Design Review Board

June 13, 2018

5:40 – 6:40	7) Recommendation Meeting: The Garden District – Greenstone Development <ul style="list-style-type: none">○ Staff Report (5-10 minutes)○ Applicant Presentation (10-15 minutes)○ Public Comment (3-minutes each)○ Board Discussion and Motions	Omar Akkari
-------------	--	-------------

6:40 – 7:40	8) Collaborative Workshop #2: 1309 West First Avenue – Trek Architecture <ul style="list-style-type: none">○ Staff Report (5-10 minutes)○ Applicant Presentation (10-15 minutes)○ Public Comment (3-minutes each)○ Board Discussion and Motions	Dean Gunderson
-------------	---	----------------

TYPICAL PLANTING STRIP &
 SIDEWALK CROSS SECTION
 FOR
GARDEN DISTRICT
 (A PLANNED UNIT DEVELOPMENT)
 CITY OF SPOKANE
 SHEET 1 OF 1

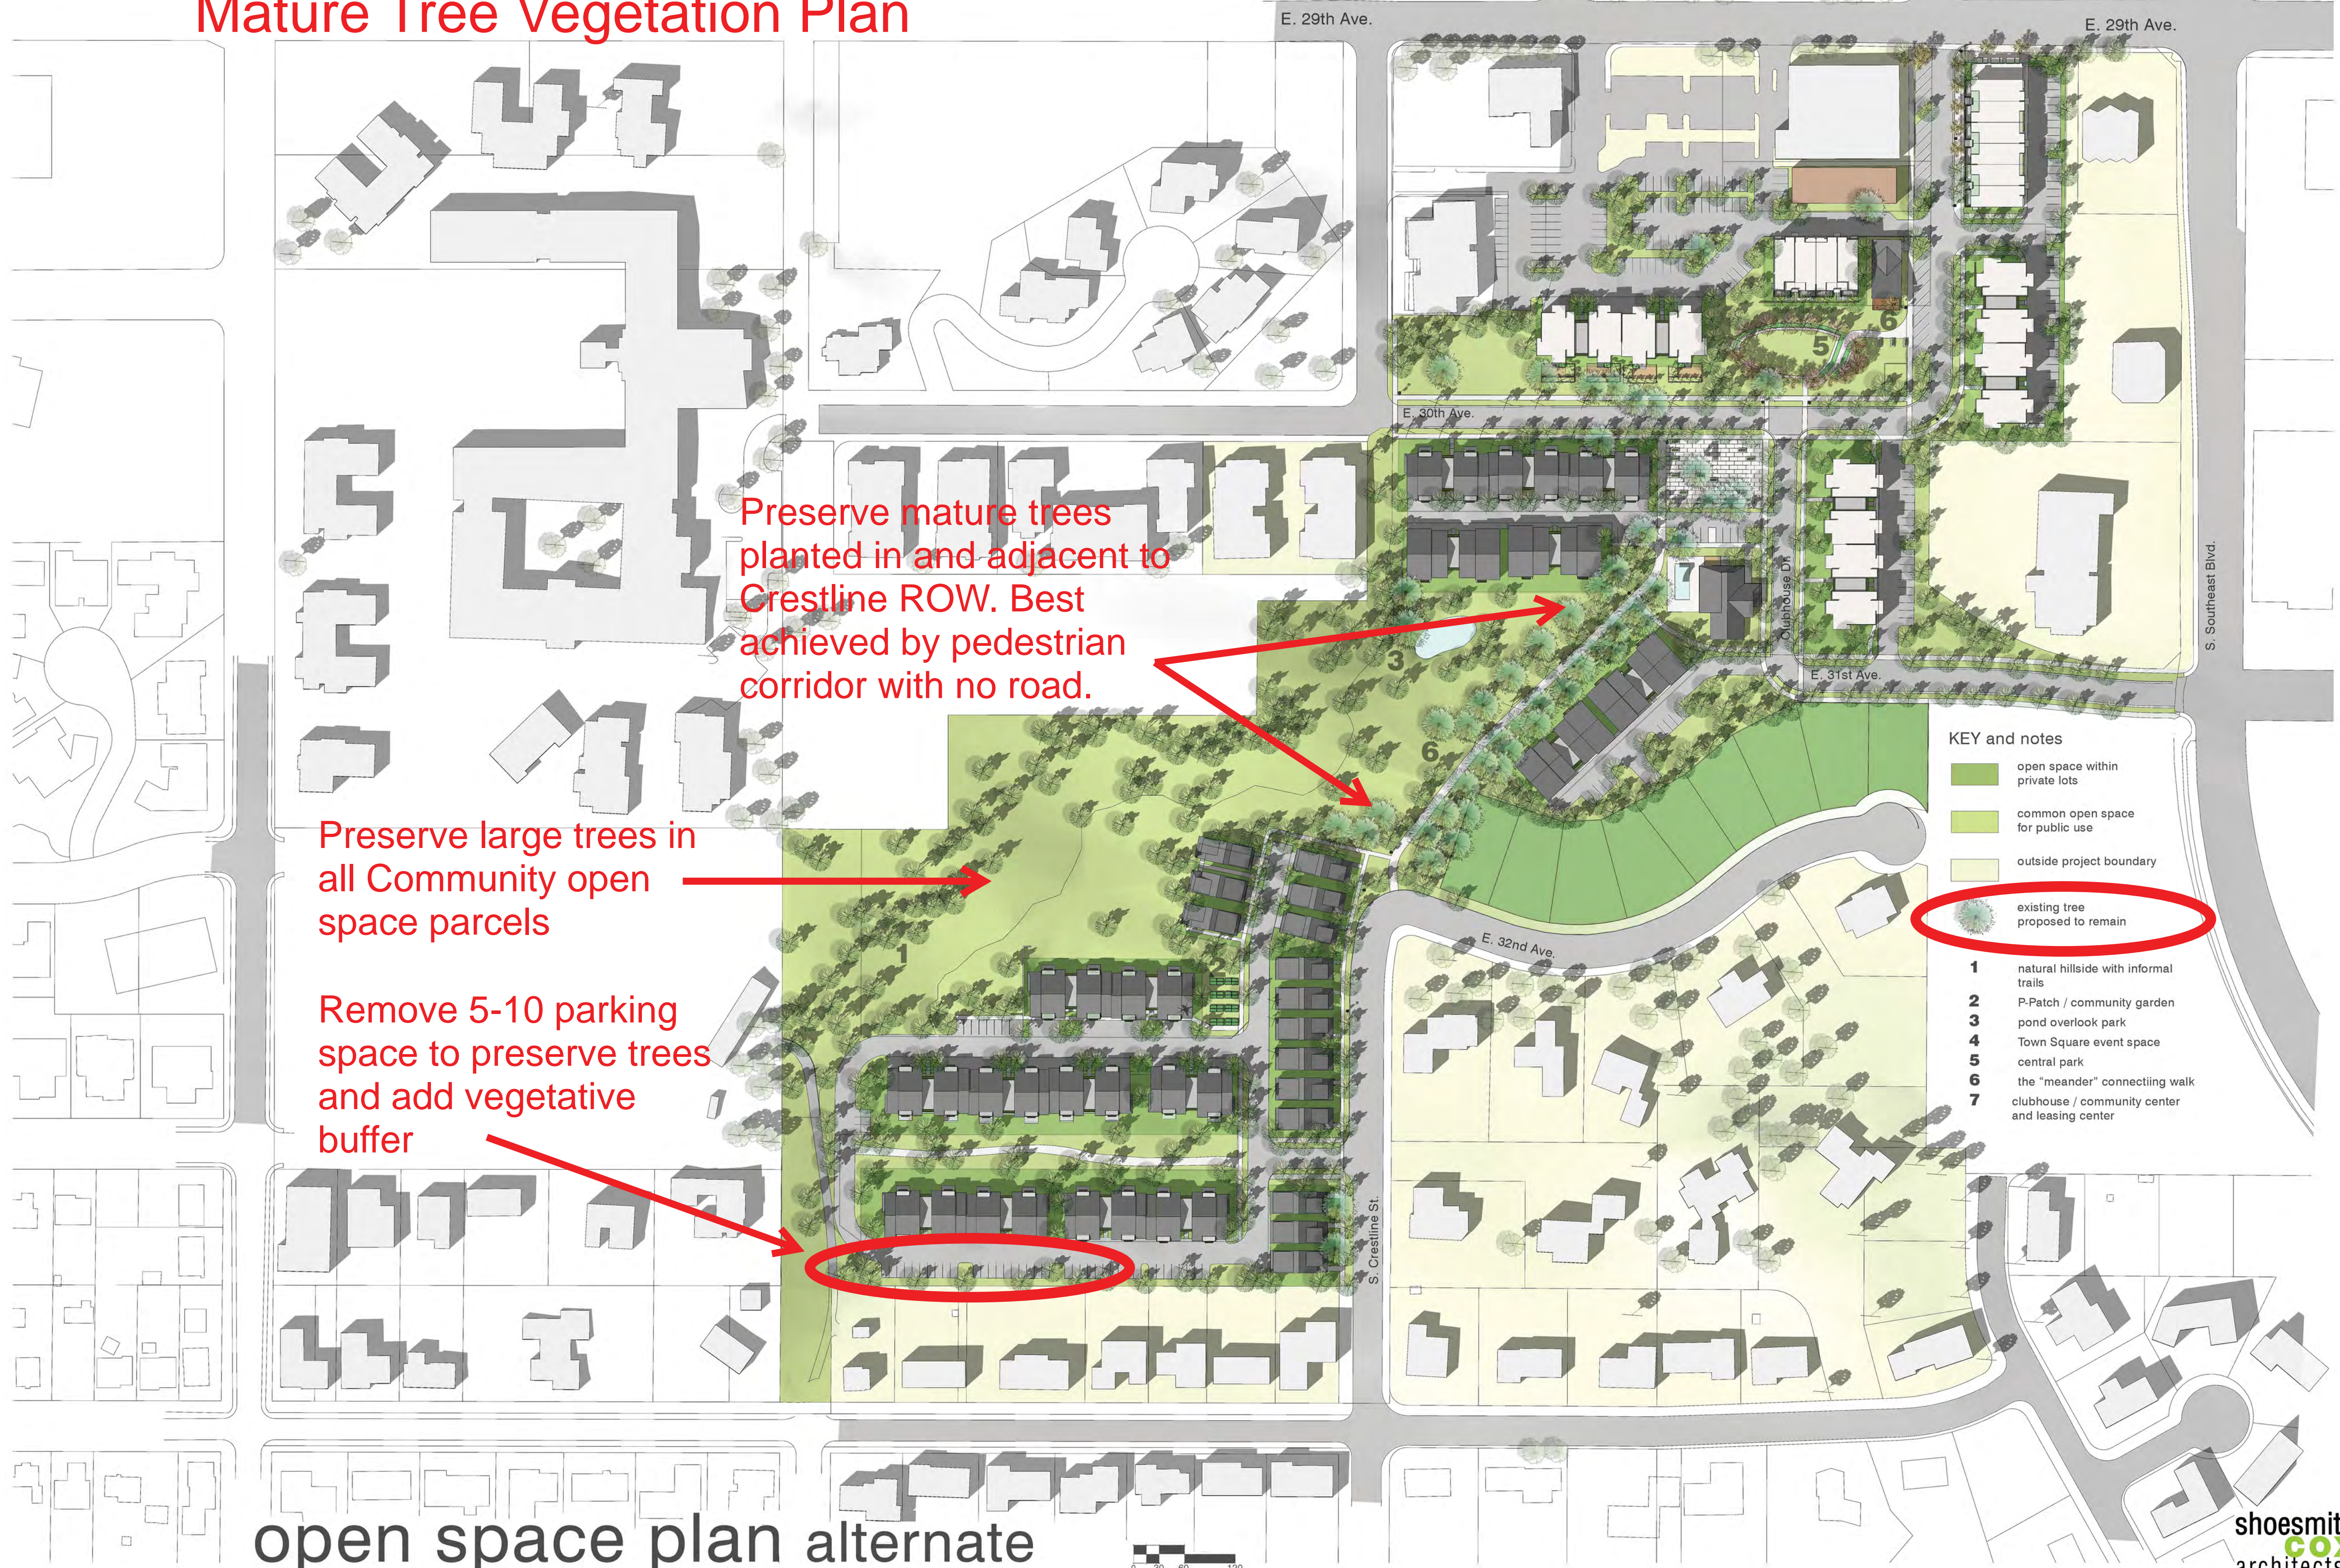
- 4. Sidewalk and Design Deviations:** We have provided street/sidewalk cross sections that illustrate the design concept in various locations in the project. We are asking DRB approval for these deviations to the extent that they vary from the CC1 Design Guidelines. We have also provided a document that identifies all of the code deviations we are requesting as part of the PUD approval. Most of these are outside of the BRD purview, but we provide them for transparency and information.

No change except: Option for 6 foot planting strip and 6 foot sidewalk in lieu of 12 foot sidewalk.

OPTION 3 (PREFERRED)

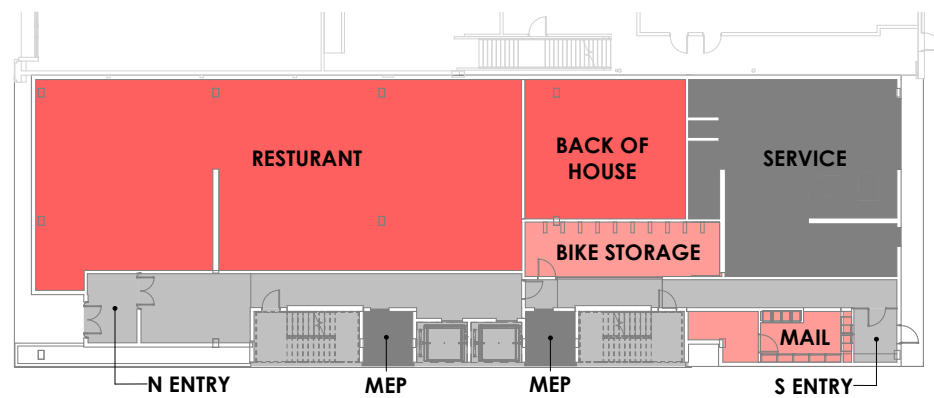
- Less contextual relationship with regard to height with adjacent building.

- The upper floors are pushed to the extents of the property line to reinforce the urban edge while the facades still maintain modulation, creating visual interest from the street level.
- Exterior patios (on the north and the south facades) are recessed to provide greater privacy for residents and visual interest.
- Ground floor commercial use is slightly recessed to accommodate a more vibrant sidewalk and pedestrian experience while being primarily composed of glass to create greater engagement with the public realm.
- The ground floor residential entry is recessed more than the commercial space to bring additional light into the commercial space from the north west corner.
- Simple, elegant facade will be expressed with glazing and material patterns.
- Code and zoning compliant, no departures required.
